January 25, 2008

Re: Application for approval to use an existing on-site wastewater treatment & disposal system.
Property Location: 13400 Andulusion Dr.
Health Department file number: **7367**

APPLICATION FOR APPROVAL TO USE AN EXISTING ON-SITE WASTEWATER TREATMENT & DISPOSAL SYSTEM

PROPOSED PLOT PLAN

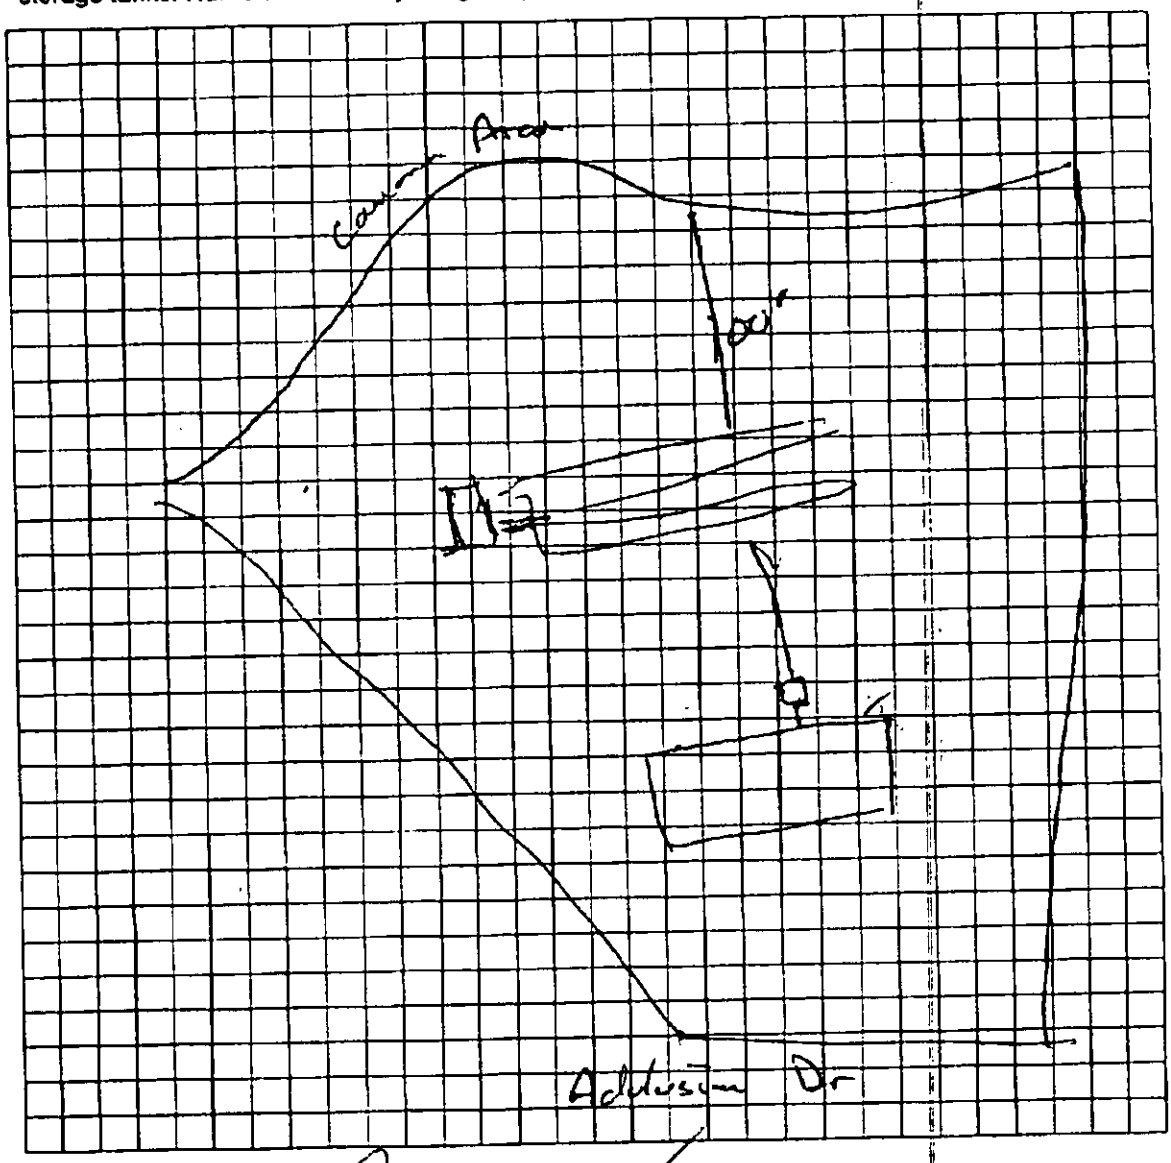
- ☐ The existing on-site wastewater treatment & disposal system was not functioning properly at the time the site evaluation was conducted.
- ☒ The proposed plans do not meet the required setbacks for the on-site wastewater treatment & disposal system serving the property.
- ☐ The proposed plans do not meet the required setbacks for the reserved repair area for an on-site wastewater treatment & disposal system.
- ☐ The proposed plans do not meet the required setbacks for water supply wells.
- ☐ The proposed project will exceed the permitted daily design flow for the existing on-site wastewater treatment & disposal system. System alteration will be required in order to accommodate your proposed project.

Denied Tank to Close to proposed deck location
Jeremy Mabe 1-25-08
EHS Signature — Date
